SAFETY EVALUATION REPORT (SER)

**Basis for Interim Operation (BIO) and Technical Safety Requirements (TSRs)
for the Decontamination and Volume Reduction (DVRS) Glovebox in Support
of the Quick-to-WIPP Project**

Technical Area 54-412

ABD-WFM-009, Rev. 0 April 8, 2004

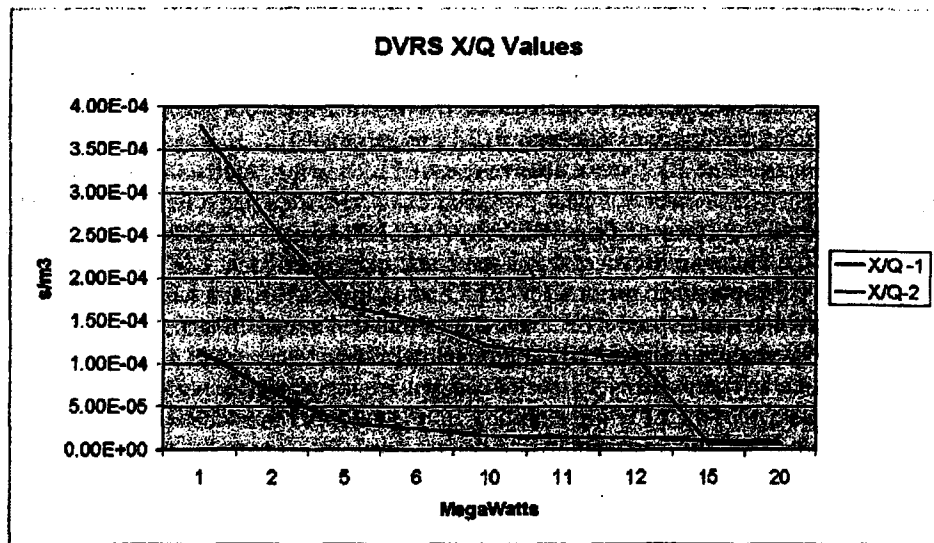
- The χ/Q values for the buoyant plumes are questionable. After reviewing the Atmospheric Input files for a 1.0 MW fire, it was noted that the facility had turned off any affects from building wake by setting the maximum value in MACCS2 for the scaling factor for entrainment of a buoyant plume "PRSLCRW001" to 1E+6. The Code Manual for MACCS2 states "If there is a need to ignore the effect of building wake entrainment, for example, for a point source release, or from a small building, this can be achieved by setting SCLCRW to its maximum allowable value." When that is done, the calculation of the plume is based strictly on the Briggs plume rise formulas, irrespective of building height and the corresponding critical wind speed." This has the effect of reducing the χ/Q value from 3.78E-4 s/m³ to 1.15 E-4 (a reduction factor of about 3.3). Unless the facility can guarantee that the building will not be standing during a fire scenario, it is non-conservative to ignore building wake

effects (downwash of plume) in conjunction with a buoyant plume. The figure below demonstrates this effect quantitatively.
